**FINAL DRAINAGE REPORT
FOR
STERLING RANCH FILING NO. 2**

Engineering Review

**May 2020
Project No. 25188.01**

PCD File No. SF-1820 **SF-20-015**

HISTORIC CONDITION

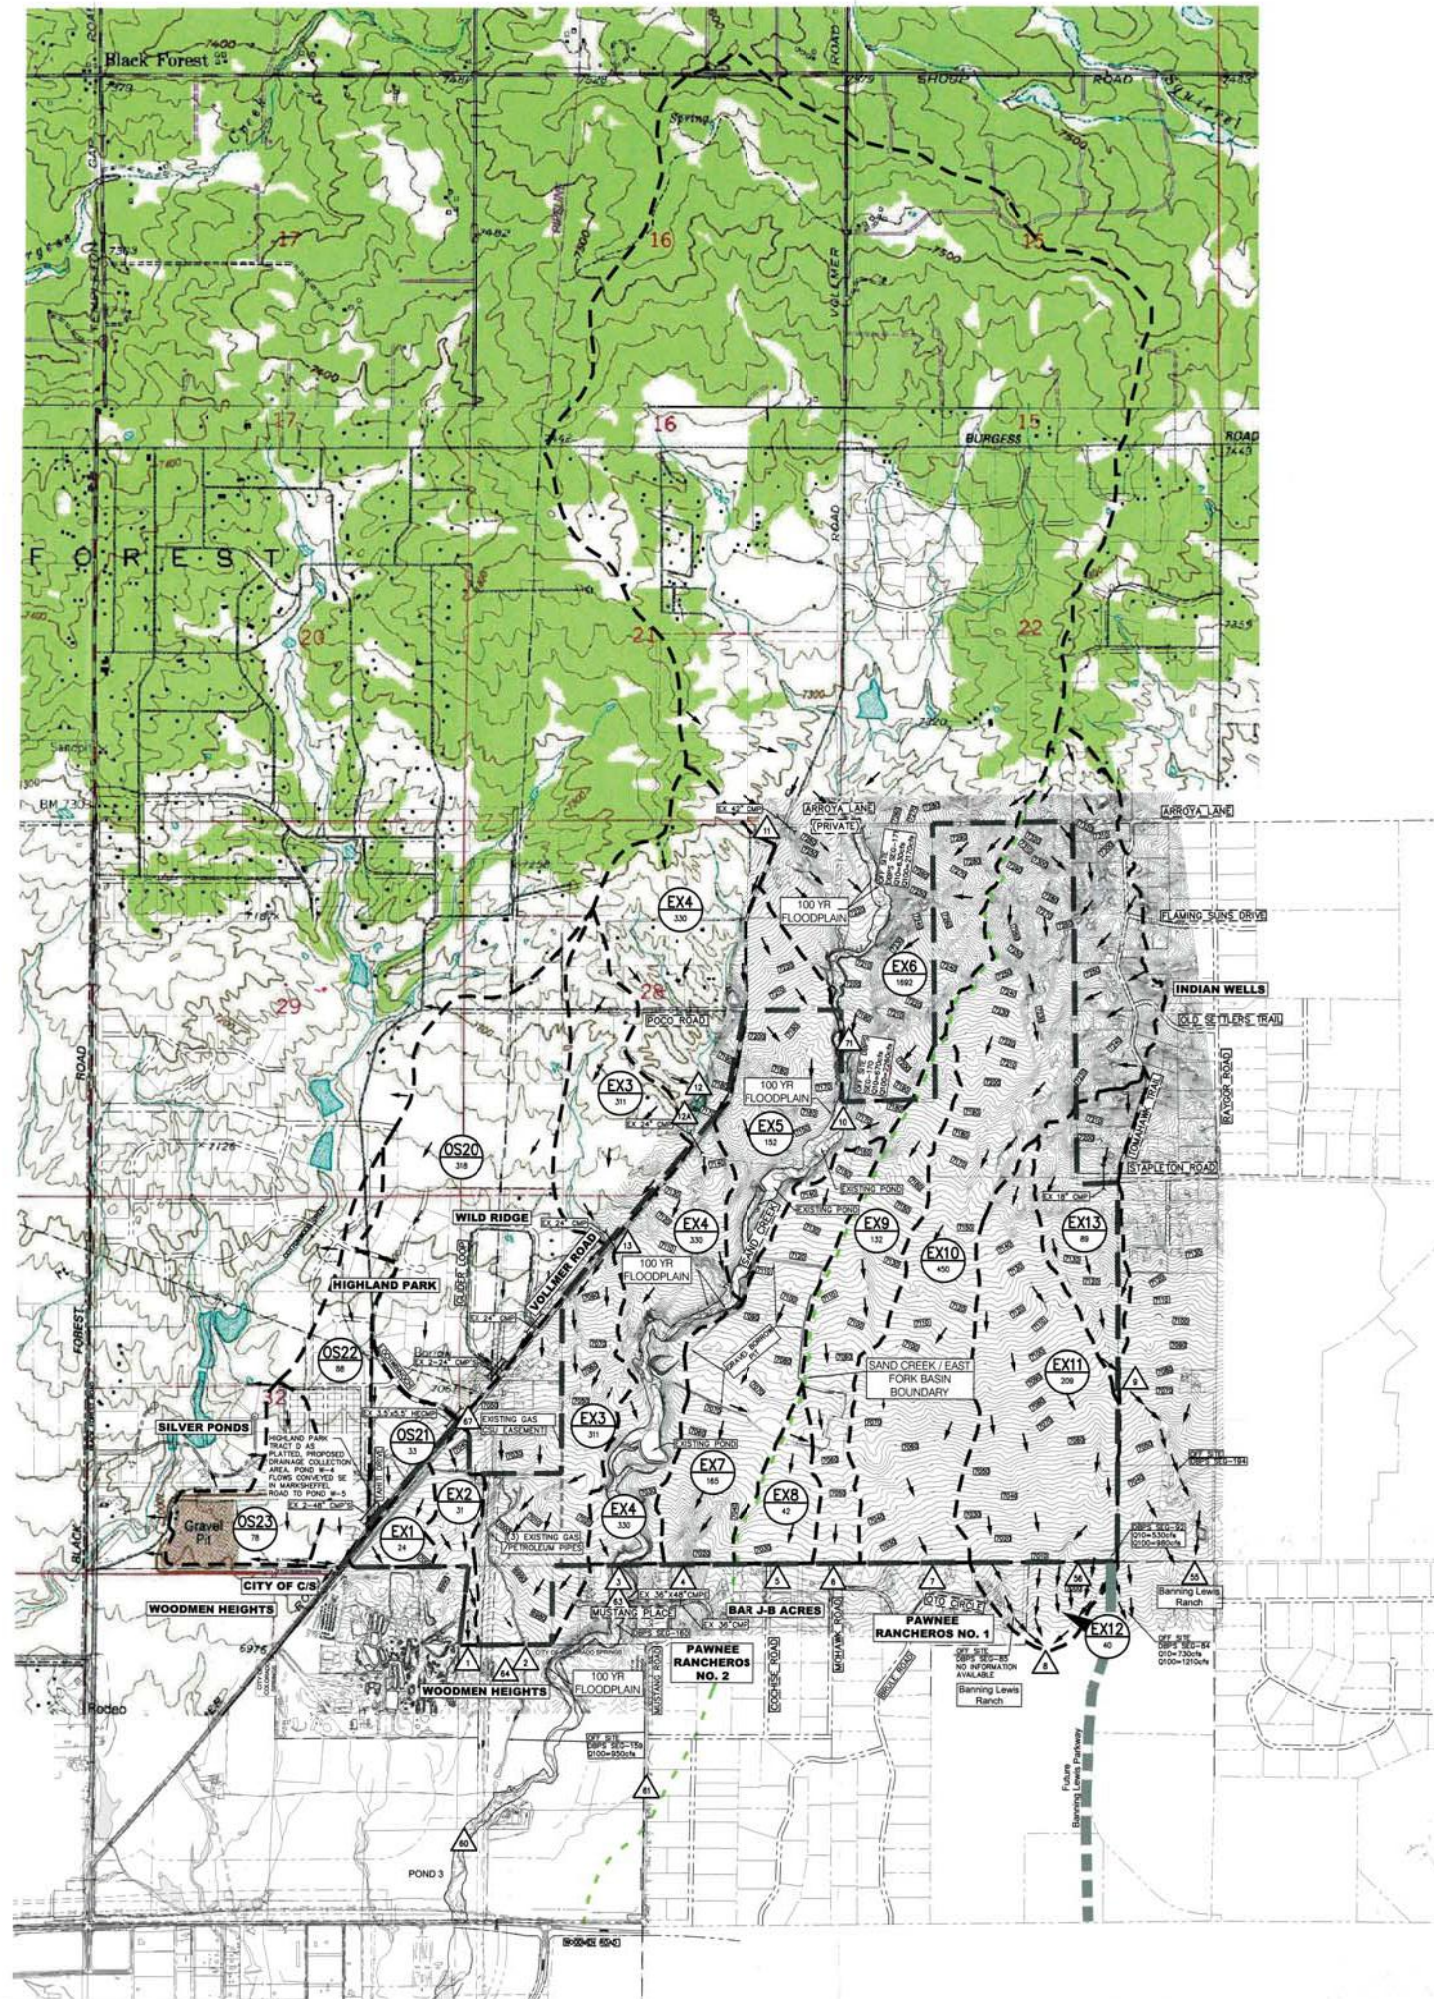
See plat
comments for
added tracts

DRAINAGE MAP
STERLING RANCH FILING 2
JOB NO. 25188.01
5/15/20
SHEET 2 OF 6

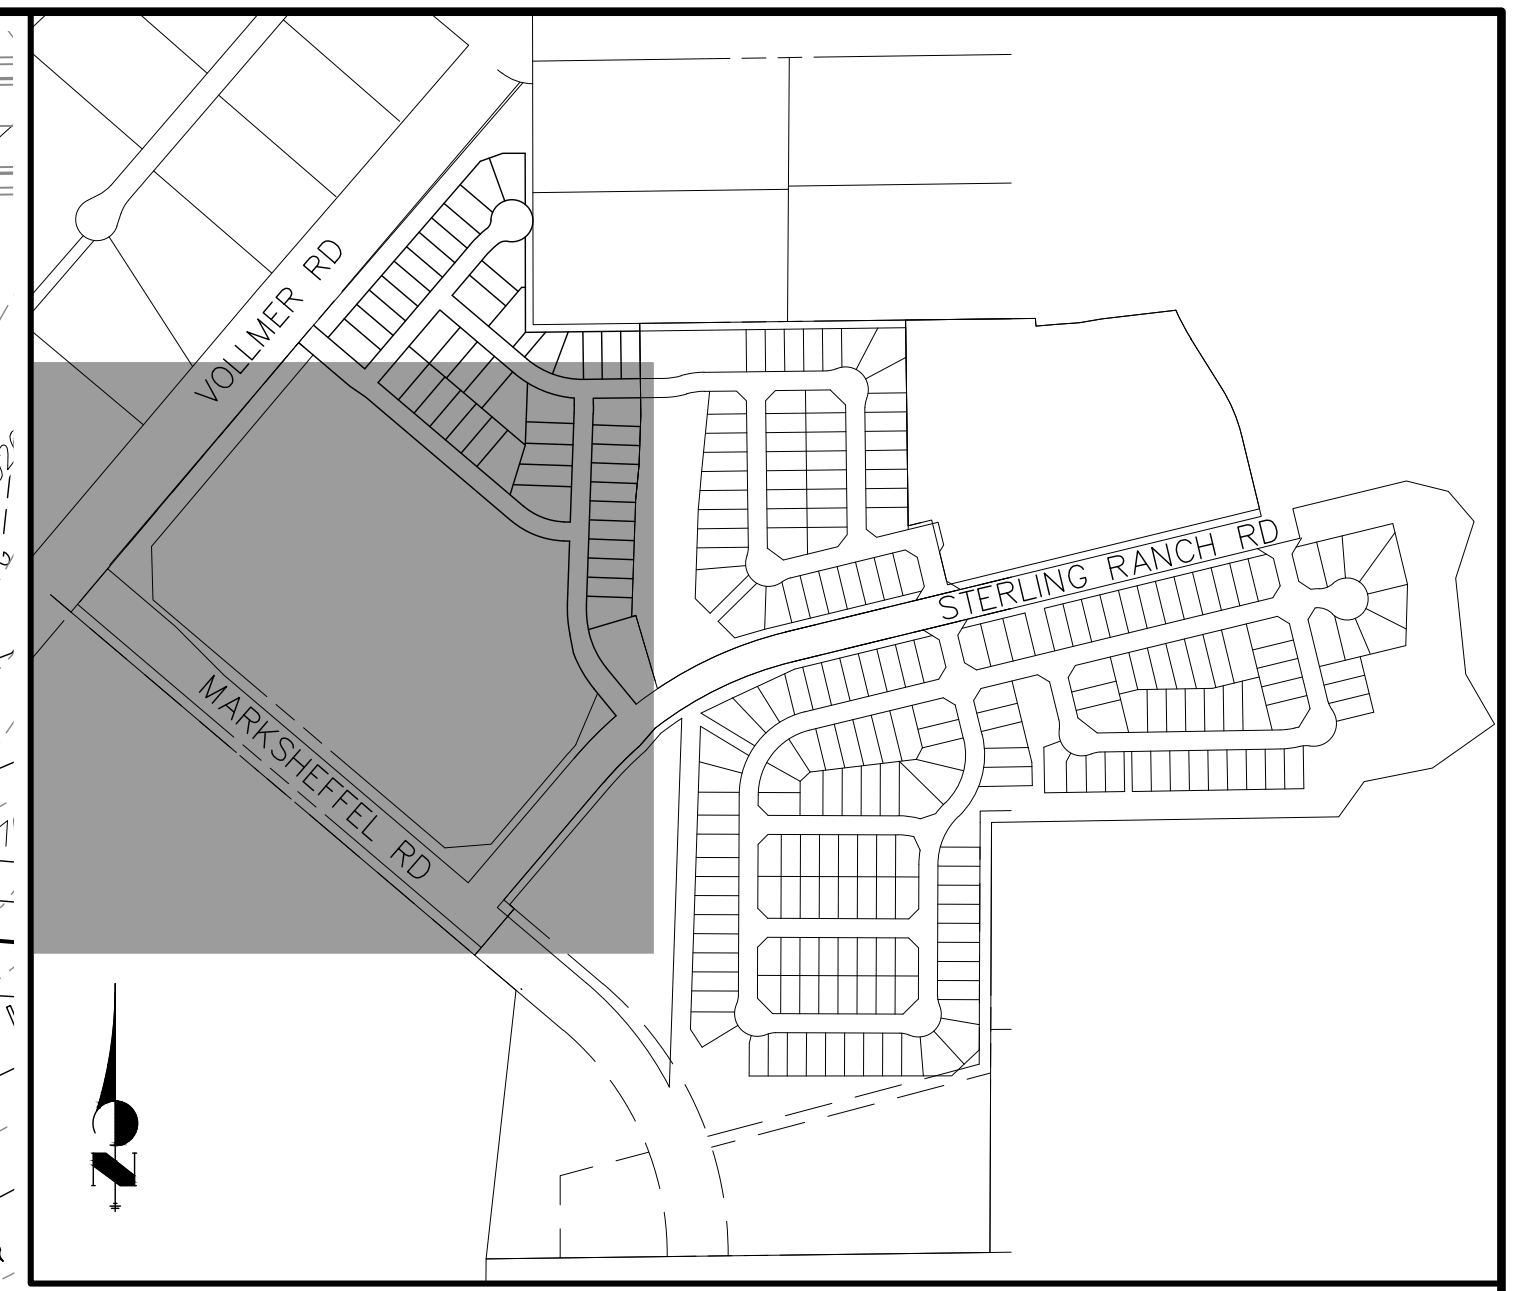
Clearly show maintenance access roads. If from Marksheffel Road instead of the north, obtain City approval

Clearly delineate the maintenance access roads from the west and/or north, not Marksheffel or Vollmer

DRAINAGE MAP
STERLING RANCH FILING 2
JOB NO. 25188.01
5/15/20
SHEET 3 OF 6

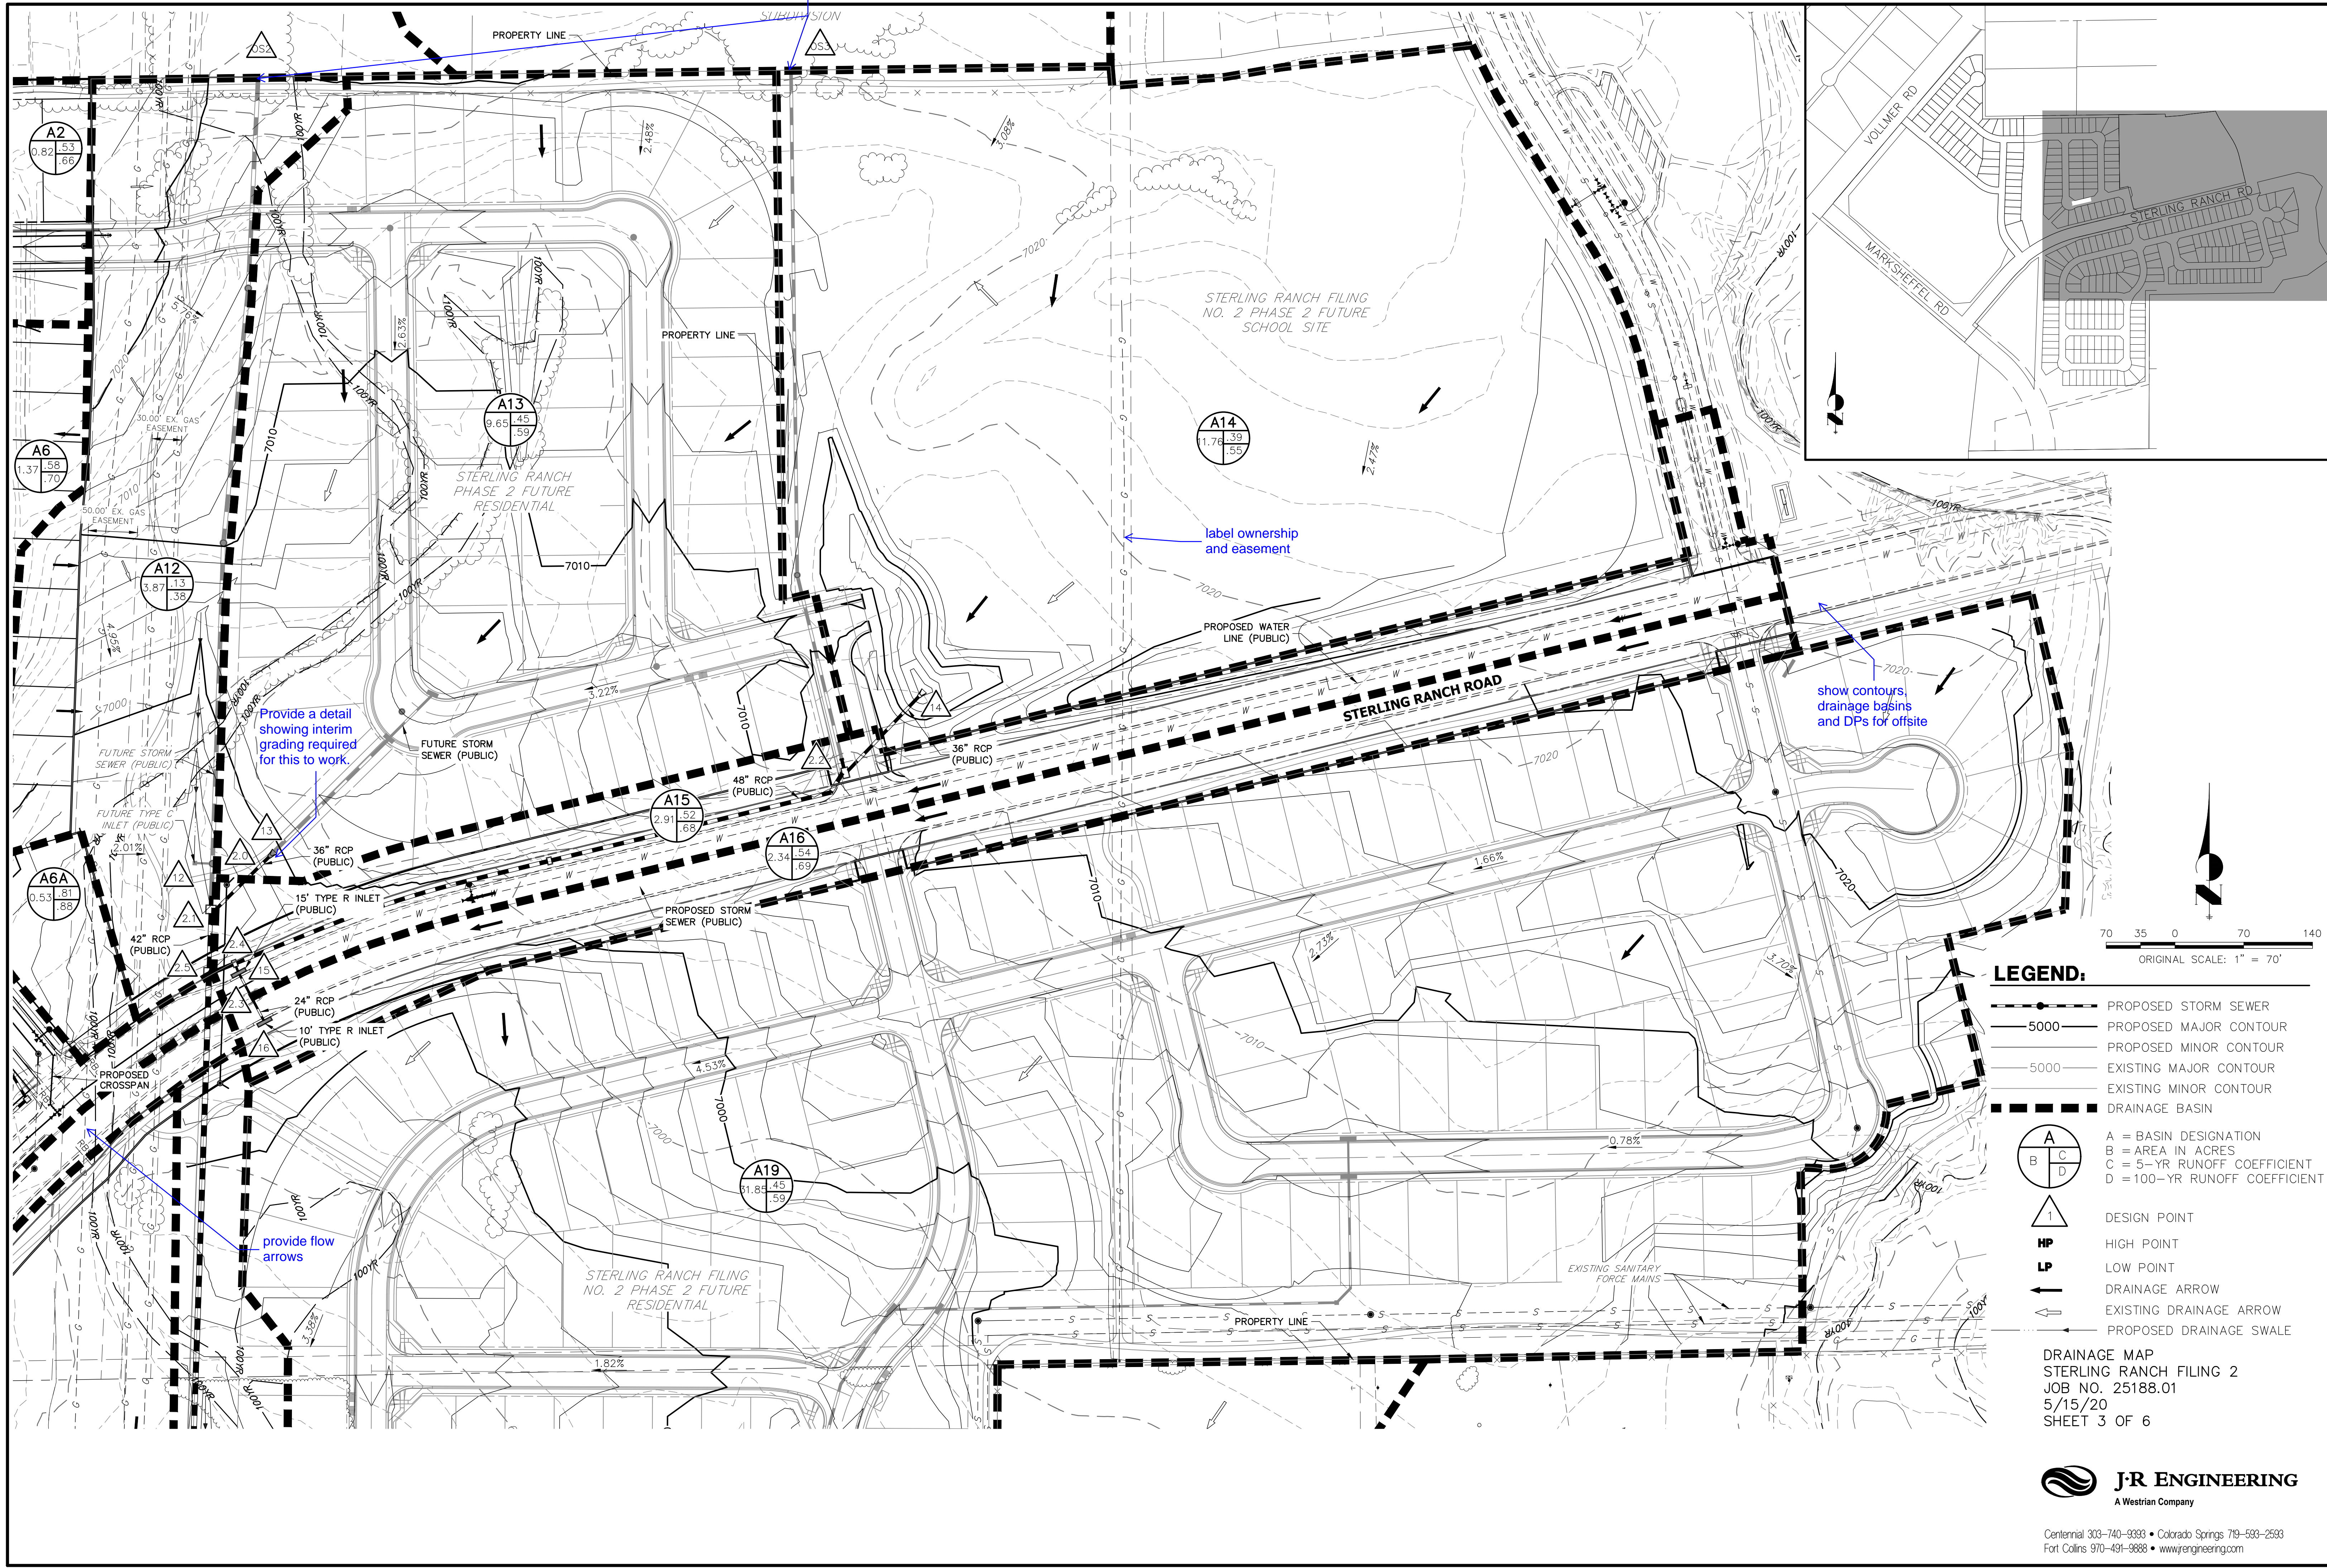
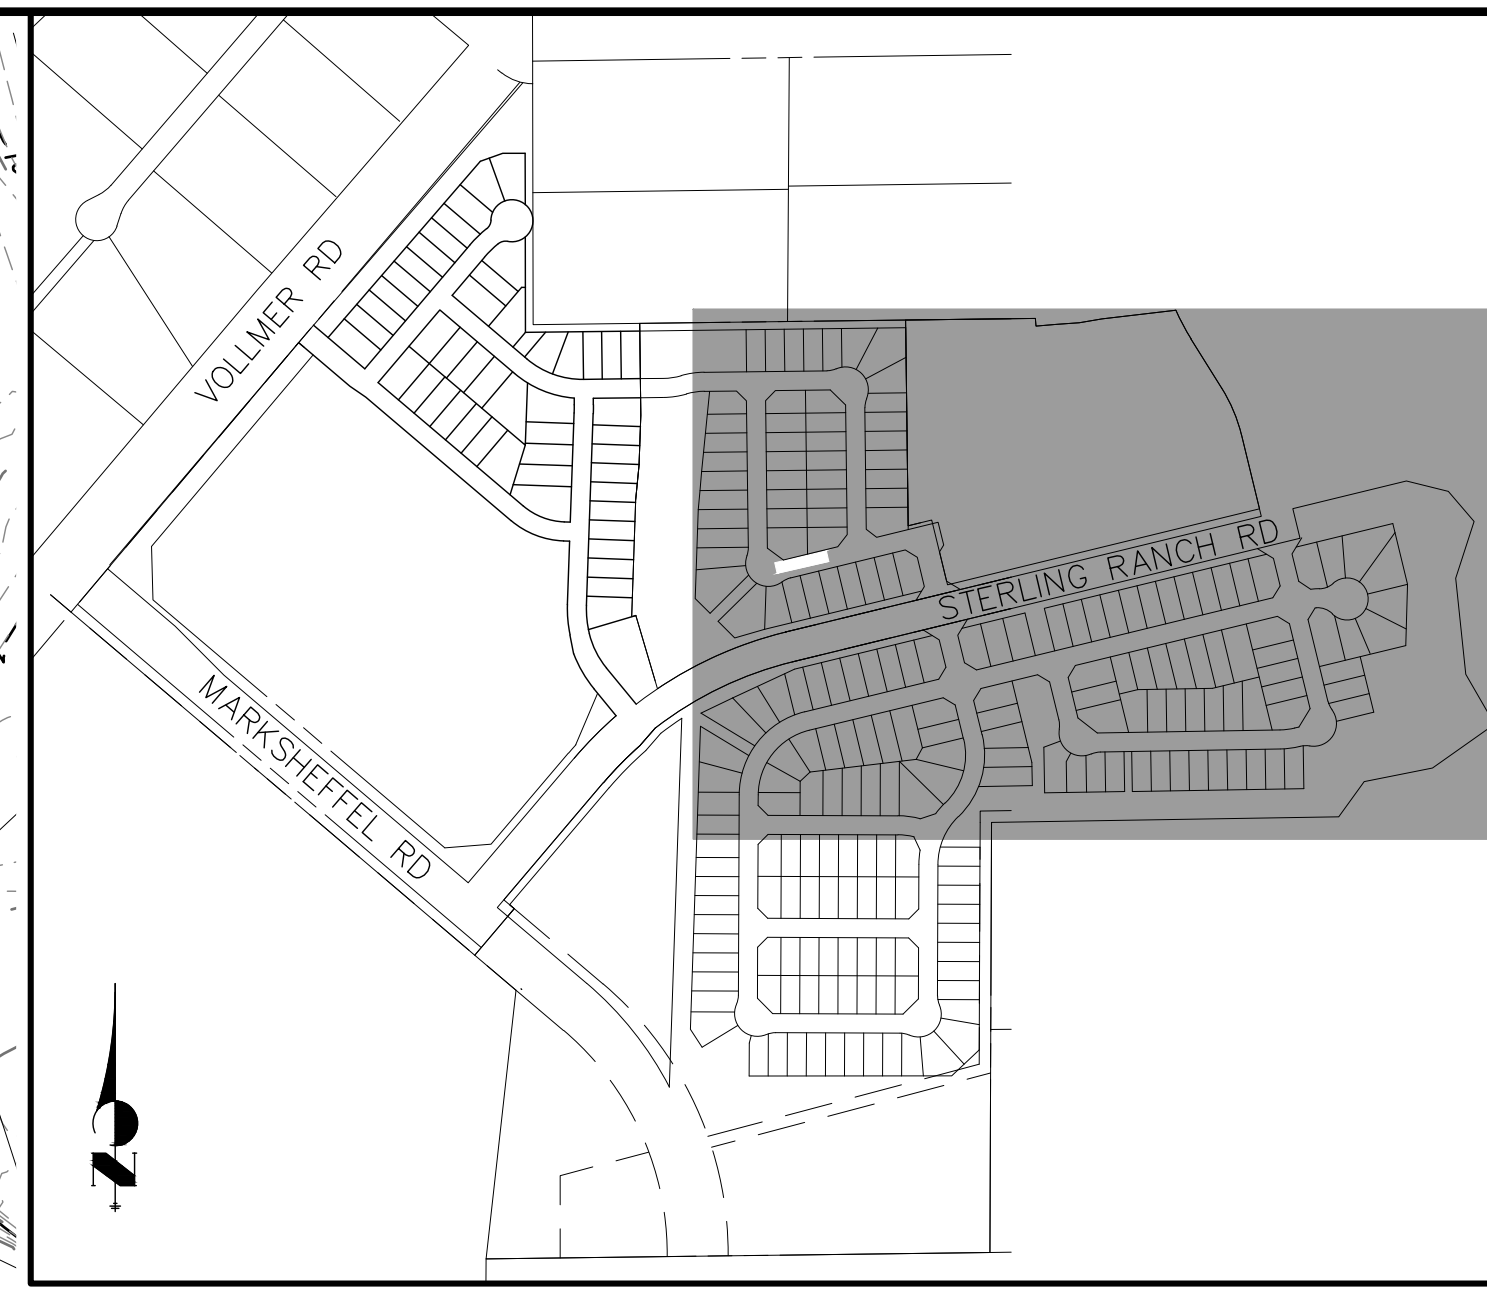
Show or reference Barbarick pond locations
do these connect to something or is grading needed to intercept flows?
